Hillrom™ Hillrom Luleå Nedre Vägen 100, 975 92 Luleå, Sweden	Field Safety Notice	FA 2021-010-002-LUL-001
---	----------------------------	--------------------------------

Subject: Missing bushing on Liko M220 and M230 causing wear and potential for falls.

Commercial name of affected product: Liko M220, Liko M230

Affected Models: 2050010 & 2050015 manufactured between 2016-DEC-27 and 2021-SEP-01.

Figure 1: Mechanism and parts included in the sling bar for M220/M230. Bushing marked in red.

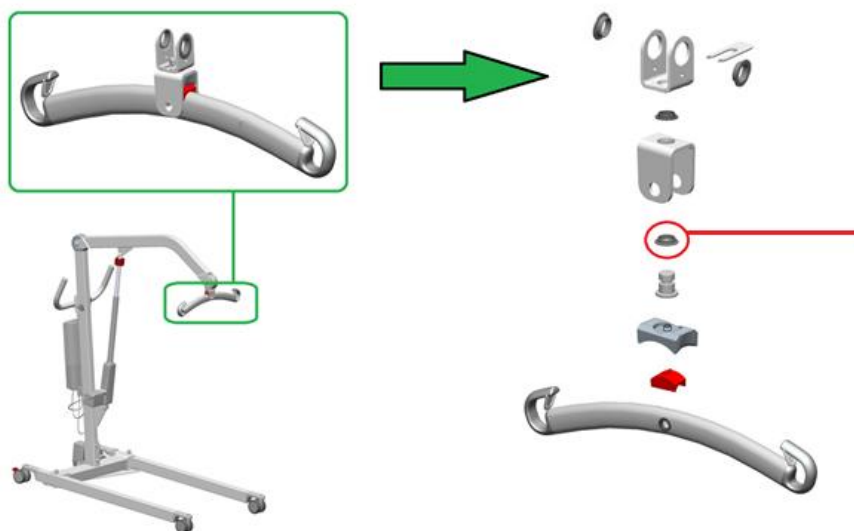
Hillrom has received customer complaints whereby a Slingbar had detached from the upper bracket of the sling bar attachment. Investigations indicated that a bushing was missing on the product. The missing bushing causes wear on the Slingbar attachment, which in turn can potentially cause the sling bar to detach from its attachment. If the slingbar detaches from the upper bracket, this has the potential for patient falls.

The sling bar on the Liko M220 and M230 mobile lift is locked into its position onto the lifting arm through two link plates, see figure 1. These two link plates are attached to each other through a bolt and a locking plate that allows for a rotation of the sling bar in one direction relative to the upper link plate.

Hillrom investigation determined that the root cause of the slingbar detachment is caused by wearing at the slingbar attachment due to the missing of a plastic bushing (see red markings in Figure 1) as part of the assembly during manufacturing of the device. It was determined that assembly of this device has the potential to not contain this plastic bushing on devices manufactured between 2016-DEC-27 and 2021-SEP-01.

Upon receipt of the response form, identifying potentially impacted devices, Hillrom or an official Hillrom distributor/representative will be in contact to schedule inspection of your device to confirm presence of the bushing. Where it is confirmed that the device is missing the bushing, a replacement slingbar with the bushing will be installed.

Figure 2: Placement of the label and its designs. Left: New design. Right: Old design.

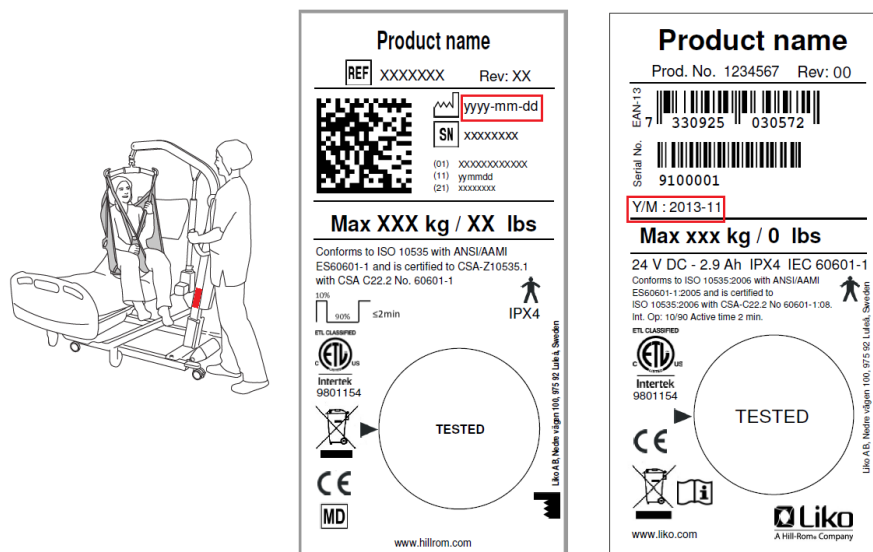
1. Review the product label on your Liko M220/M230 to determine if it is impacted by this field action by identifying the manufacturing date of the device (i.e. Manufacturing date between 2016-DEC-27 and 2021-SEP-01). See figure 2.
